Proposal

Proposal: The Sound Amphitheater, Extended Stage Gutter

Owner: City of Clearwater

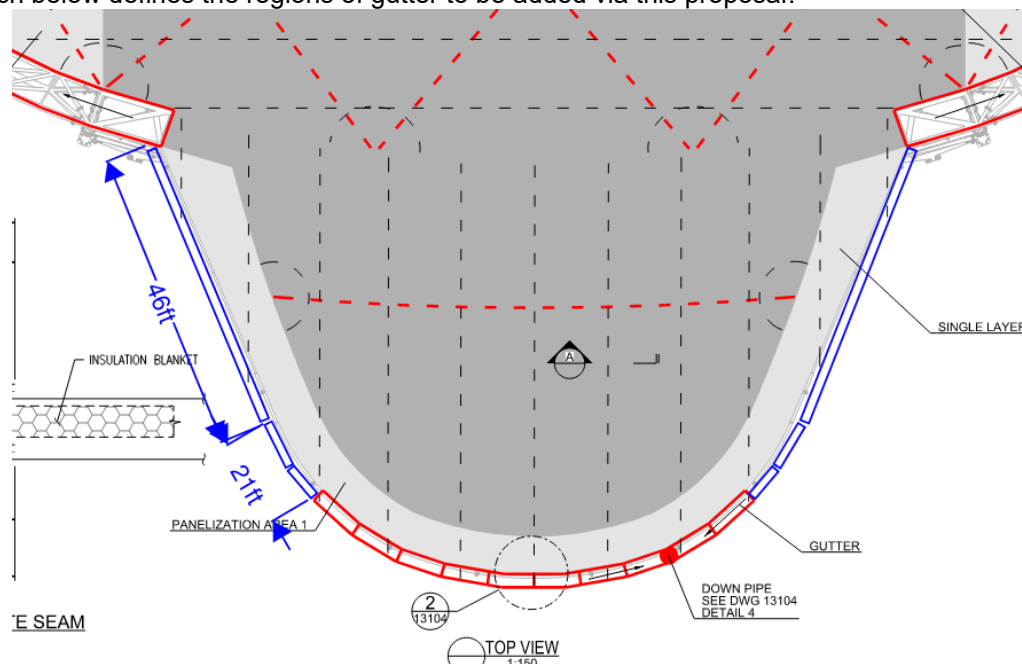
Birdair, Inc., will detail, supply and install a gutter system of similar detailing and construction to the existing stage gutter to extend said stage gutter around the full perimeter of the stage. The proposed gutter is per the approved sizing provided by Stantec after their hydraulic / hydrologic studies / drainage studies. In general, the gutter:

The sketch below defines the regions of gutter to be added via this proposal:
